**PERALTA COMMUNITY COLLEGE DISTRICT  
LANEY COLLEGE  
LIBRARY & LEARNING RESOURCE CENTER (LRC) PROJECT  
BID NO 23 24 03**

**ADDENDUM NO. 02**

**PROJECT:** Laney College Library & LRC

**DATE:** 03 May 2024

**5 STAFF ROOM - KITCHENETTE**  
A8.75 3/4" = 1'-0"

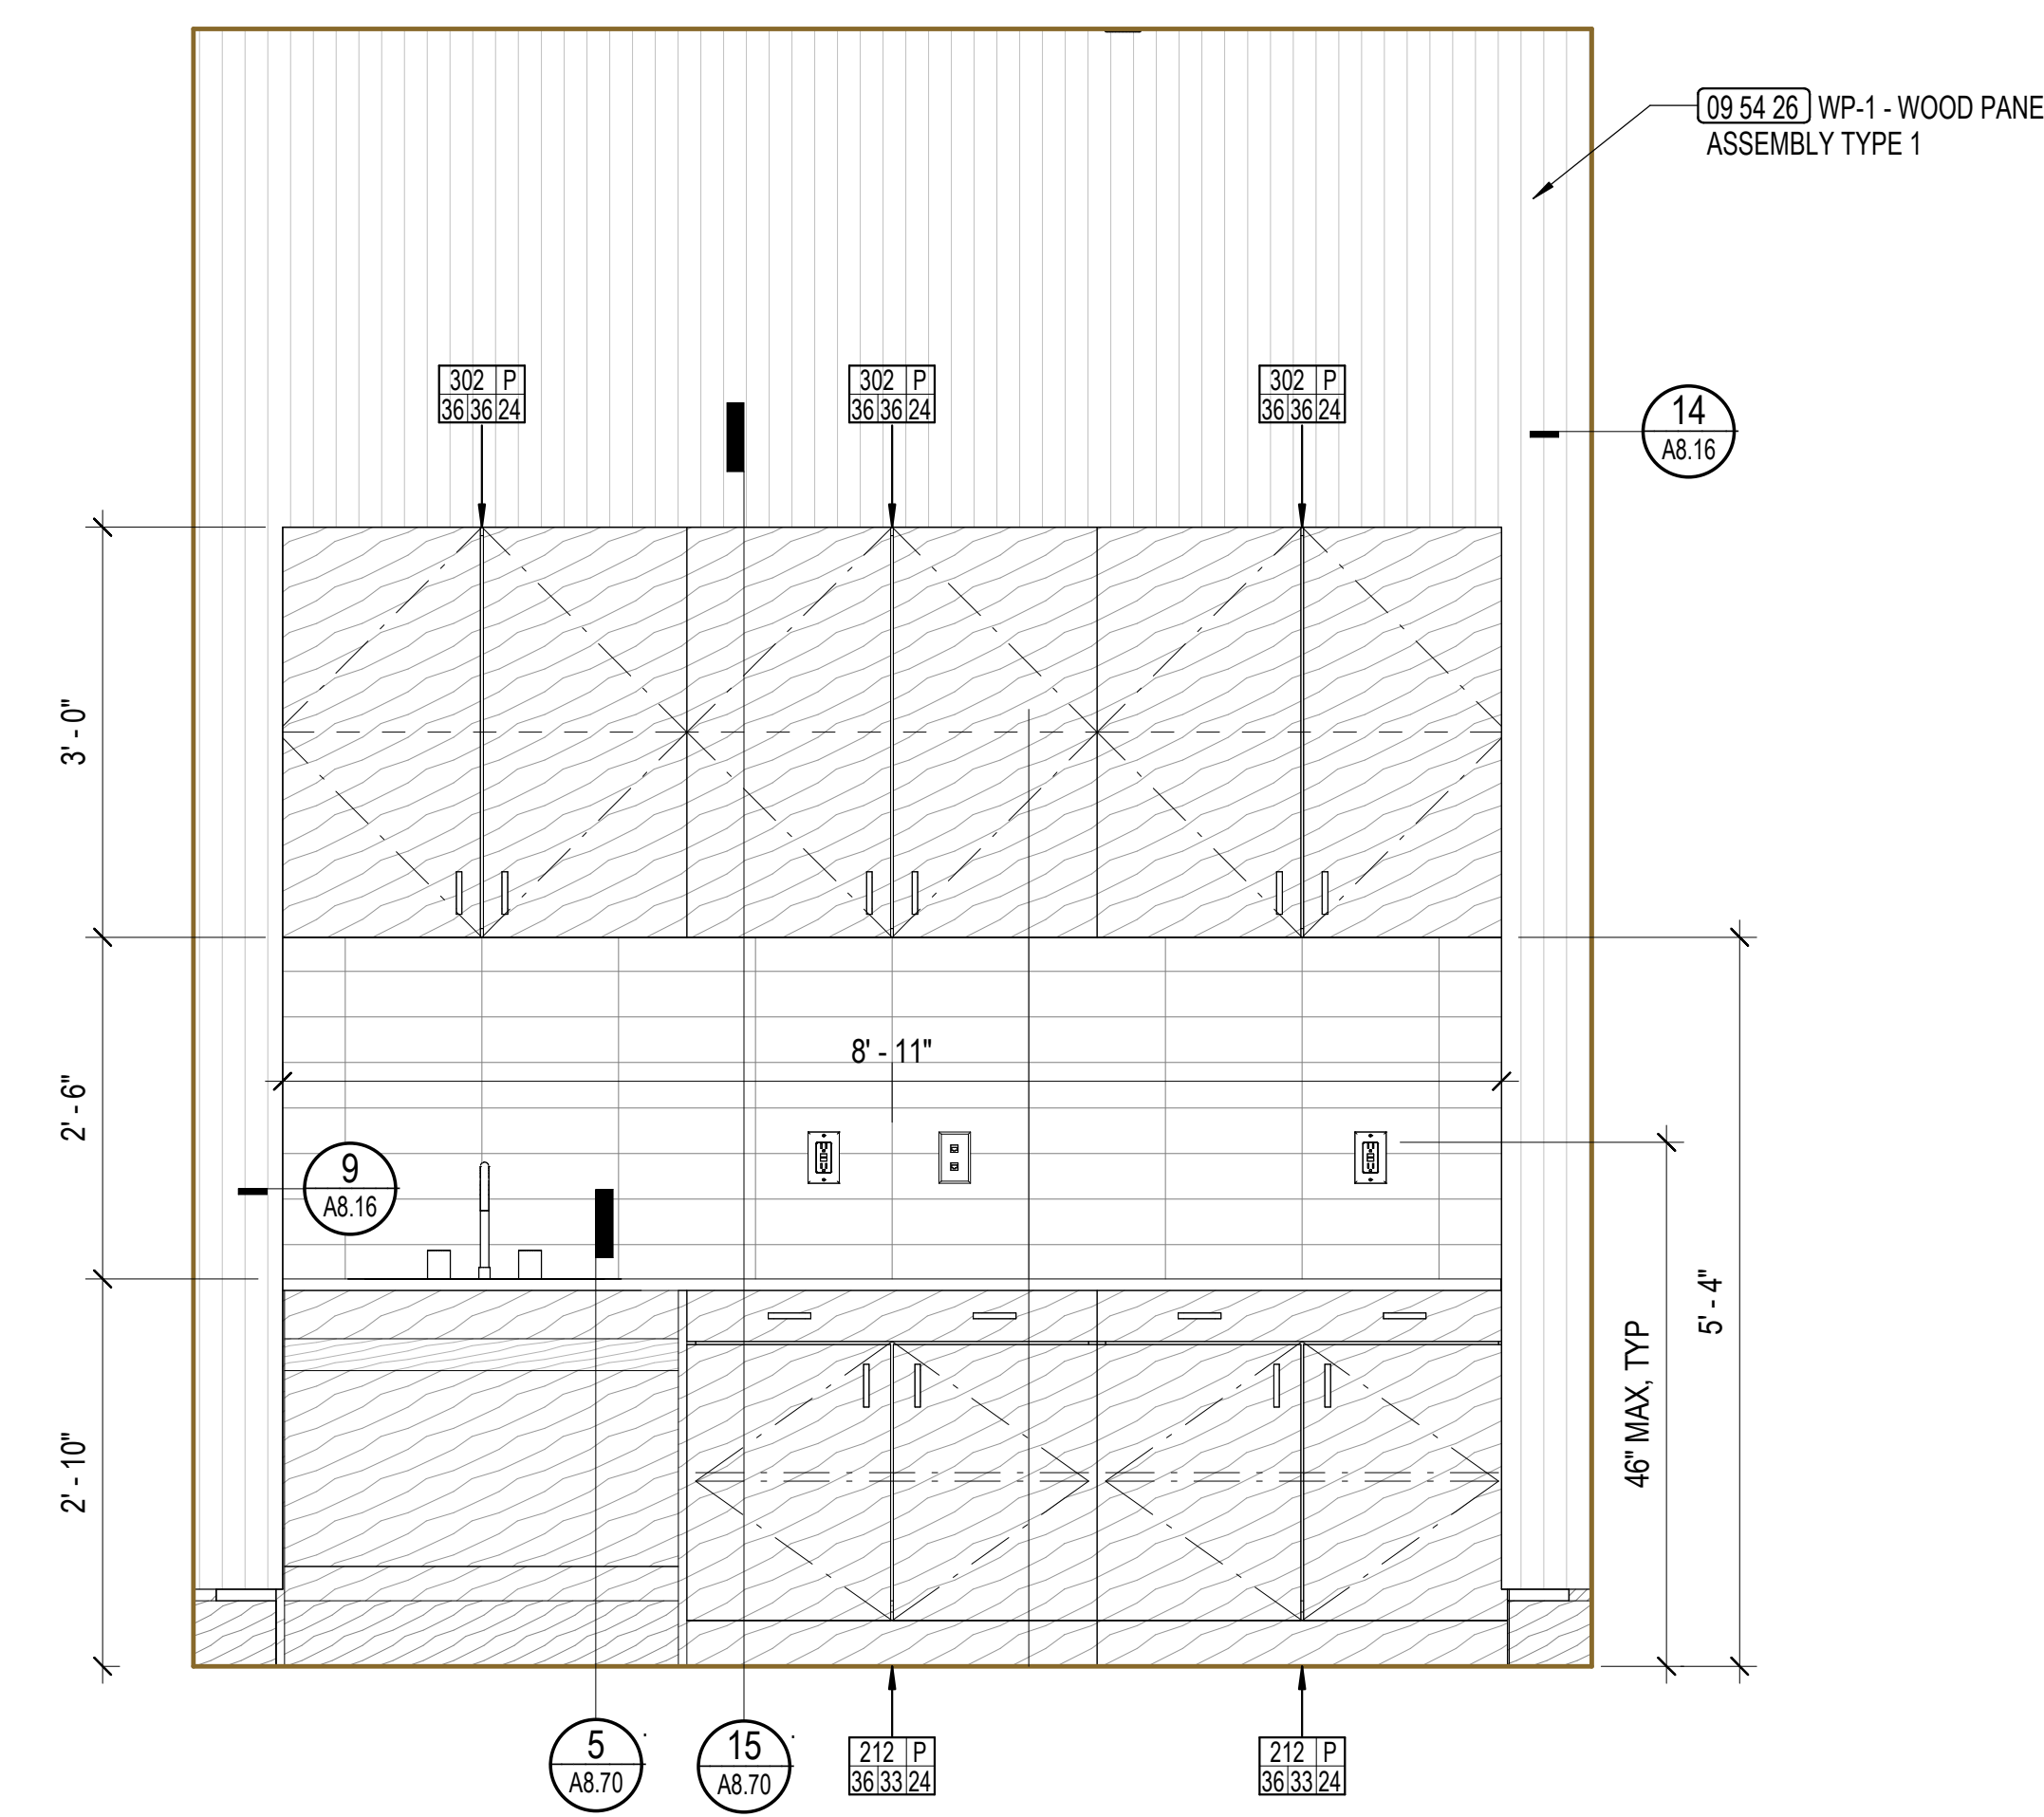
6. Item No. ADD-2.06

Reference: Detail 5/A8.75

Description: Staff Room Kitchen Appliances  
Reference Bidder Question 013.

A See Addendum 02 (Item No. ADD-2.06) Detail 5/A8.75 showing procurement for the Staff Room kitchen appliances.
